STAFF REPORT

Re: Vista 600 West Phase 2 Building A — Site Plan Amendment Request

Application No.: 2023-0293-SP
Applicant: Eric Winters, representing Wasatch Residential Group
Project Location: Approximately 13645 S. 600 West
Current Zoning: TSD (Transit Station Development) Zone
Acreage: Approximately 6.98 acres (304,048 square feet)
Request: Request for approval of a Site Plan Amendment application in the TSD zone for the reconfiguration of a retail building pad.

EXHIBIT H
ELEVATIONS

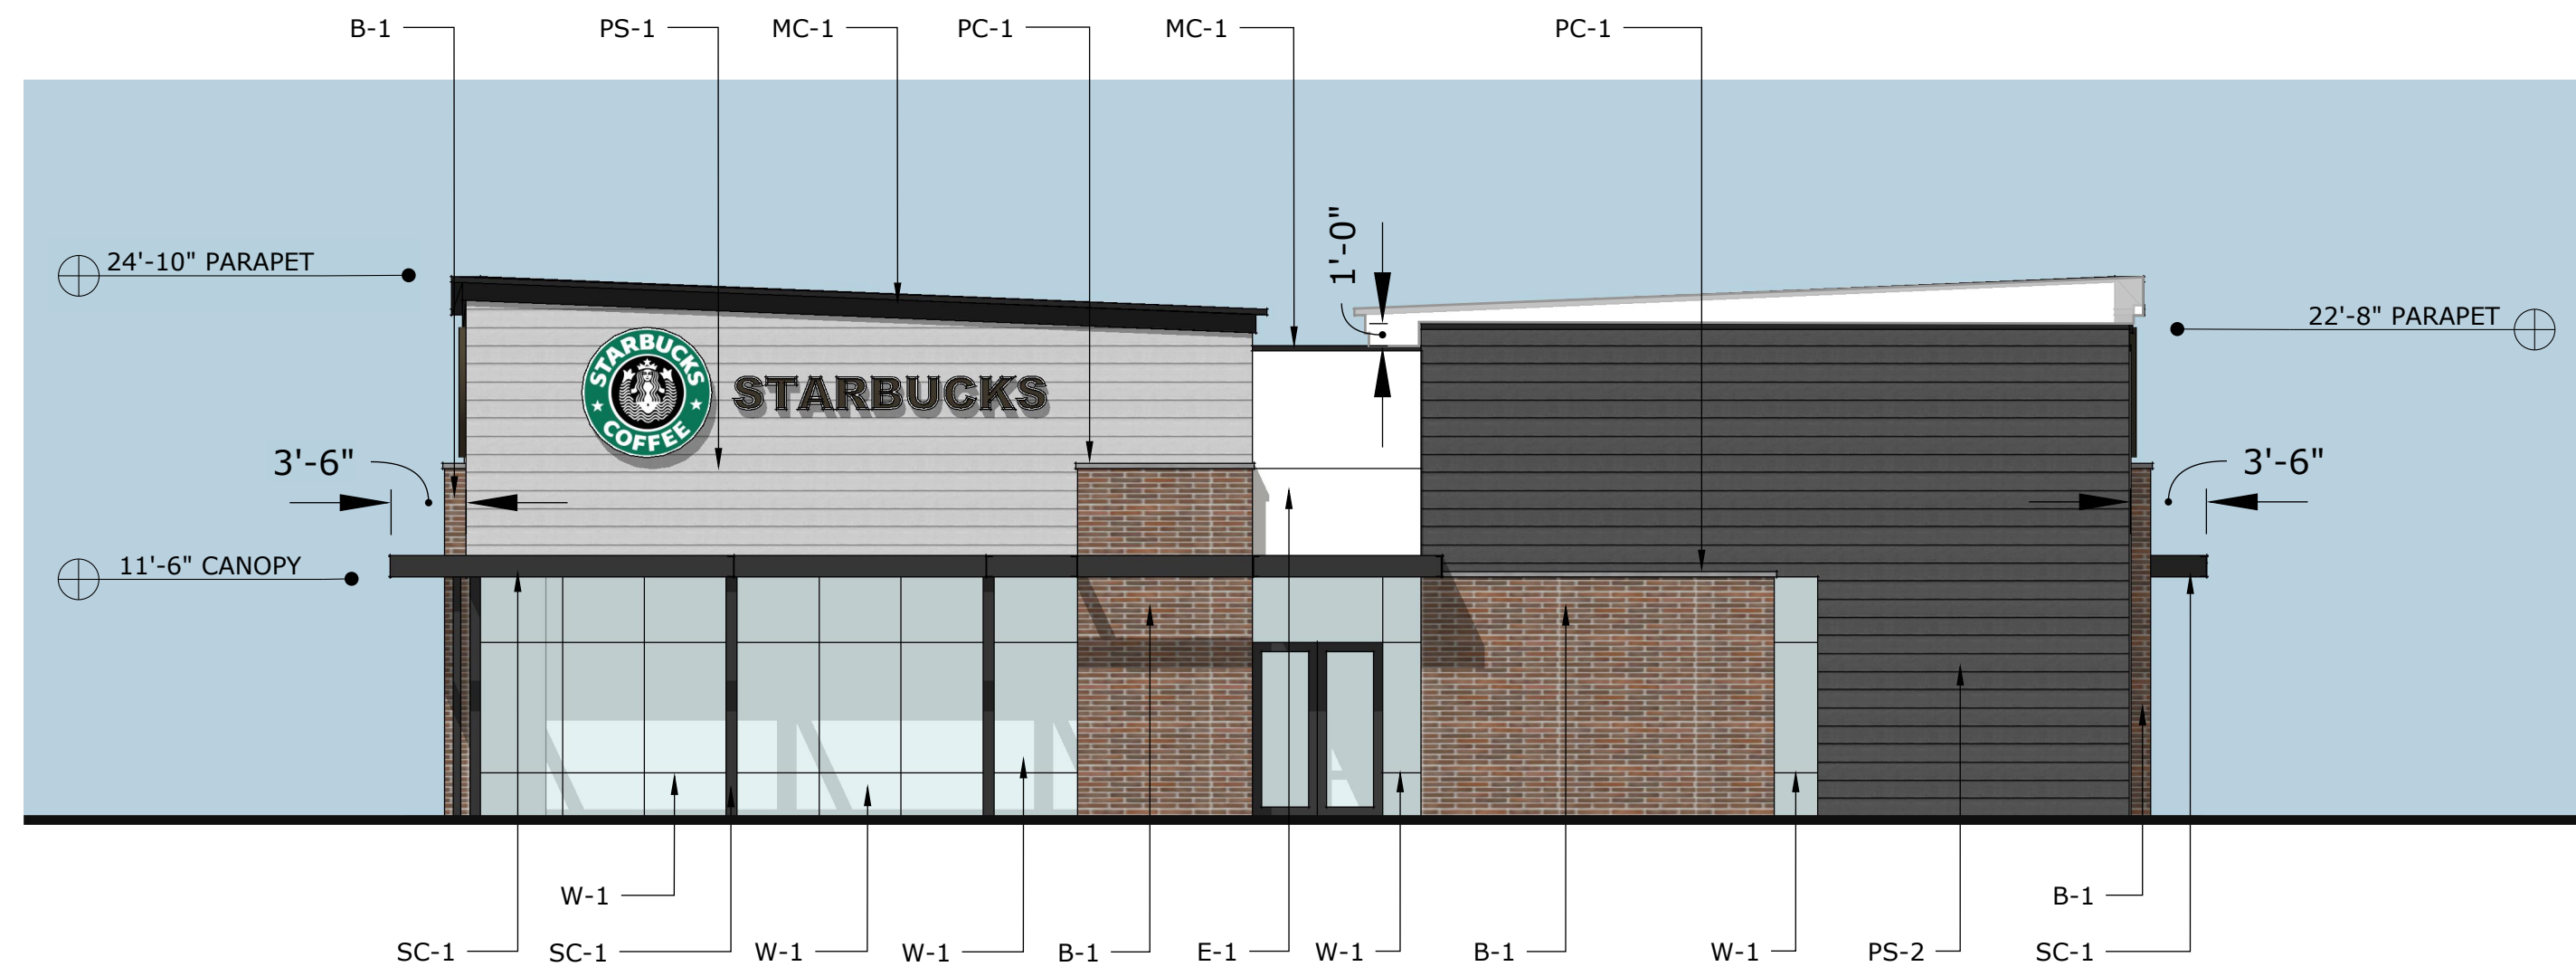
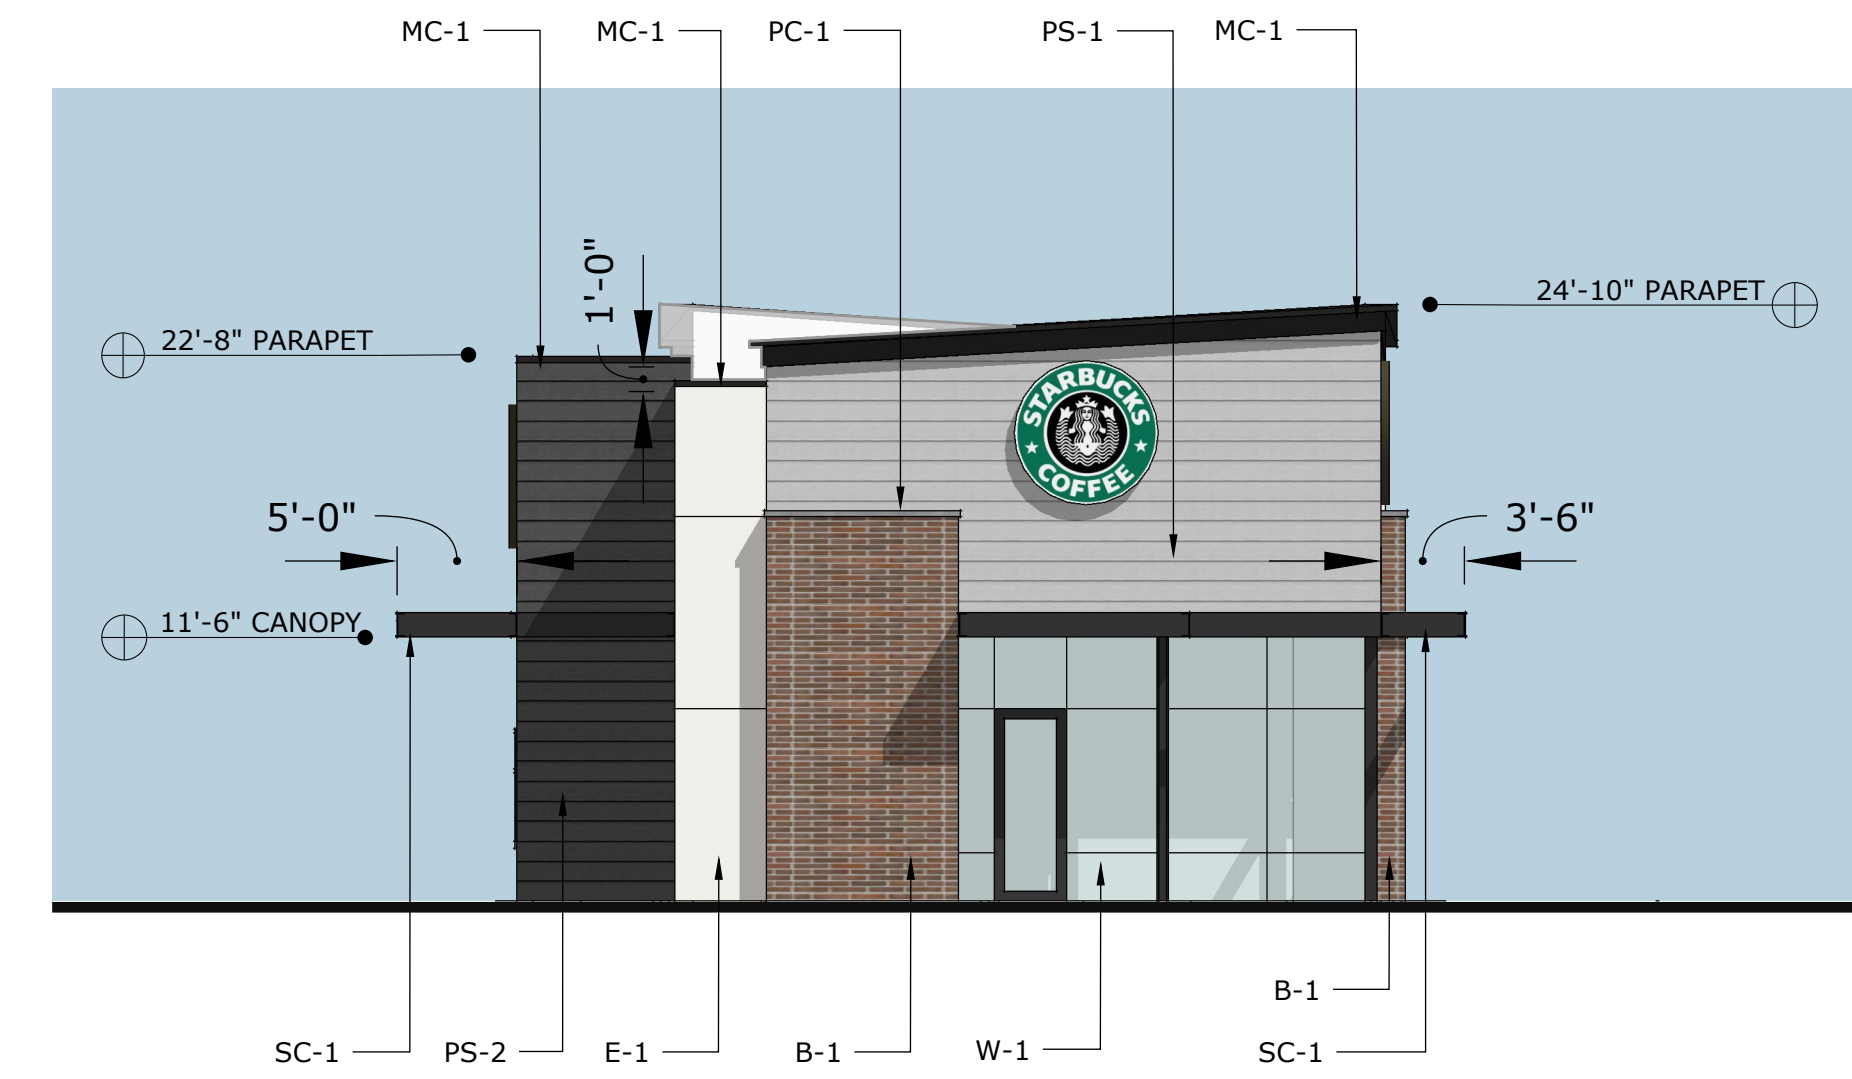
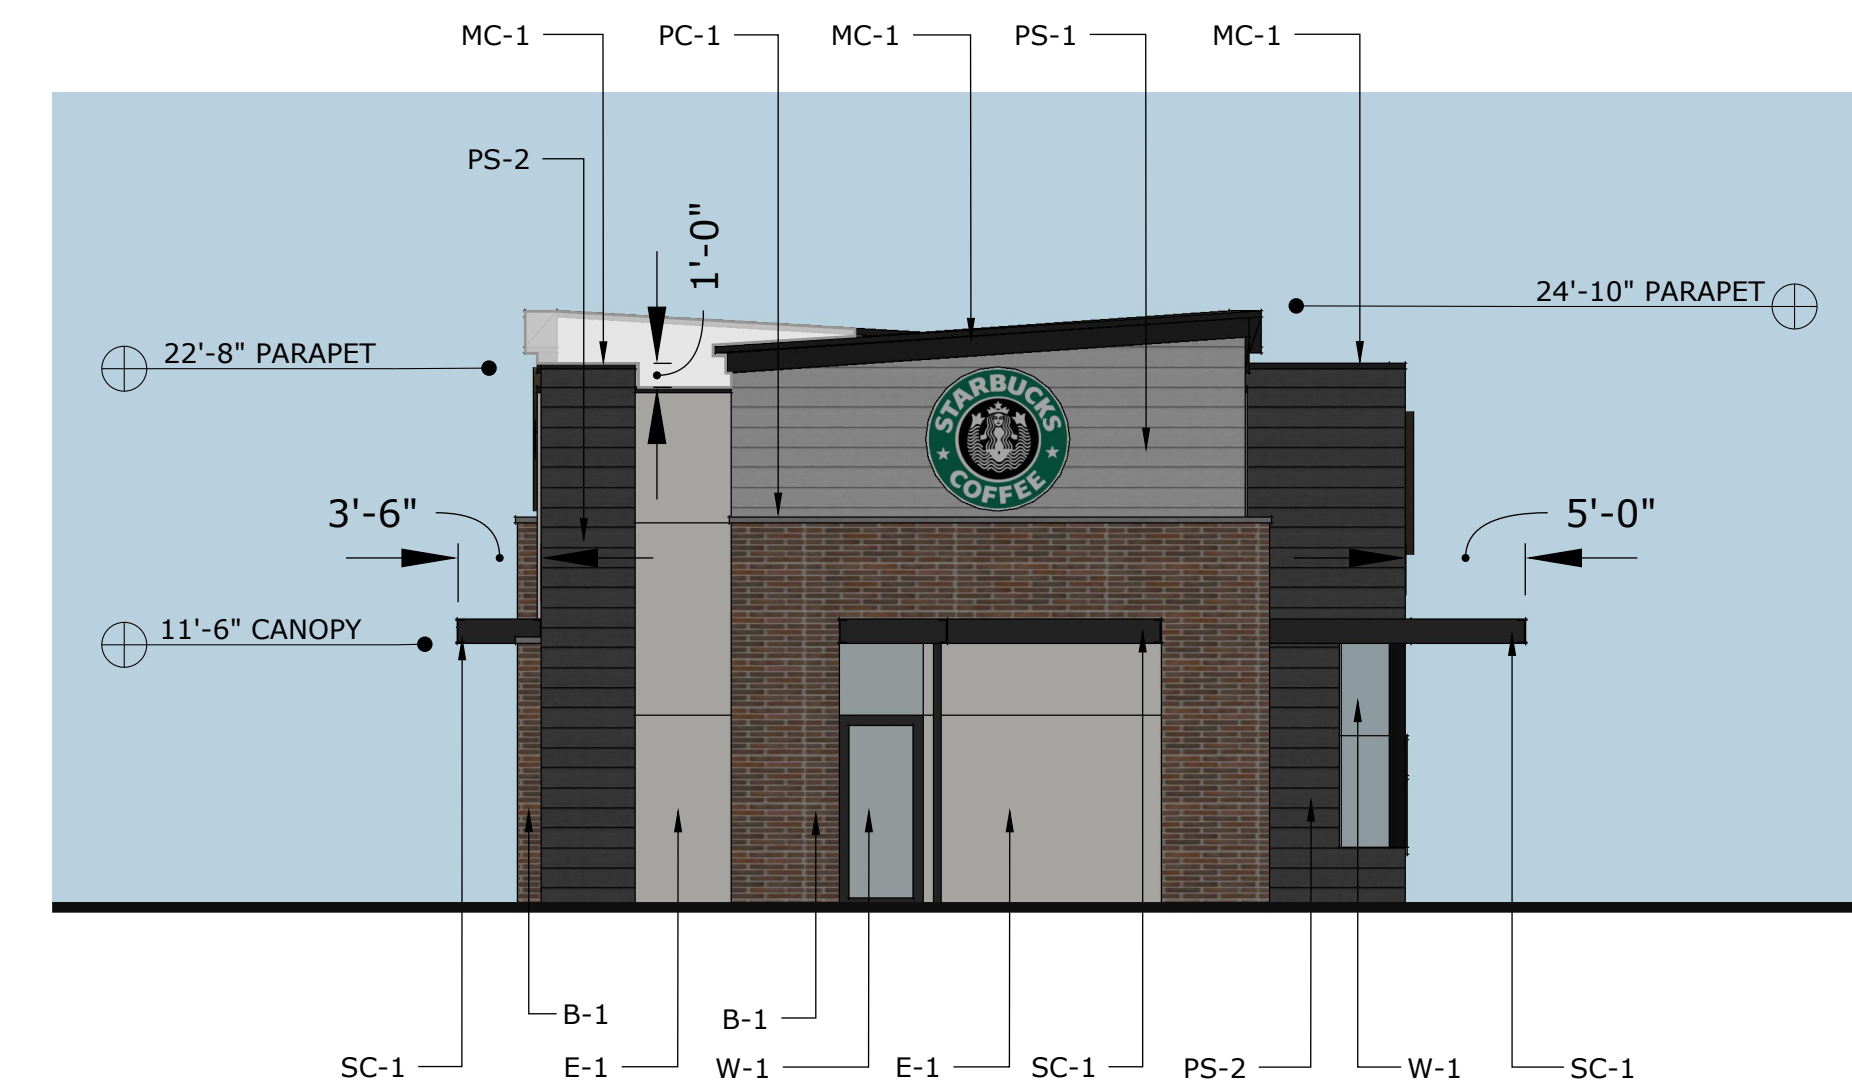
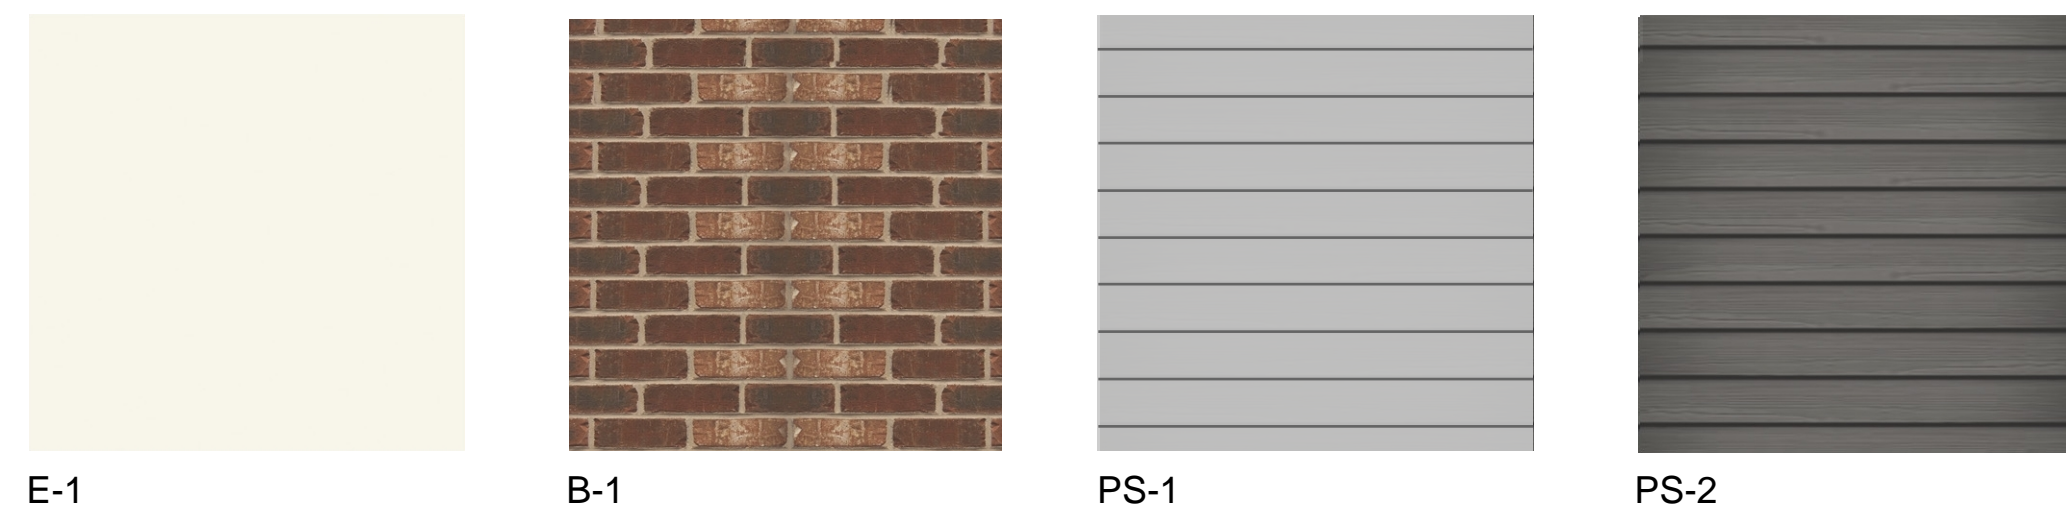
Architecture. The proposed retail designated buildings will all remain one story in height in line with prior approvals (Exhibit H). This site is located in Area 3 of the TSD zone and there is no minimum or maximum height for buildings in the zone. The adopted MAP has design standards for all of the building types and the proposed project meets those guidelines.
